REGULATION No. 7

A. PROPOSAL

**Front End-outline marker lamp**  
**(AM)**

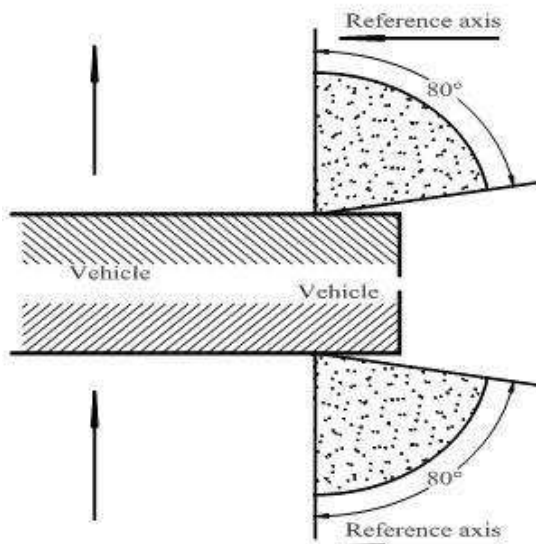
Annex 1, amend to read:

"FRONT AND REAR POSITION LAMPS, END-OUTLINE MARKER LAMPS AND STOP-LAMPS: MINIMUM ANGLES REQUIRED FOR LIGHT DISTRIBUTION IN SPACE OF THESE LAMPS <sup>1/</sup>
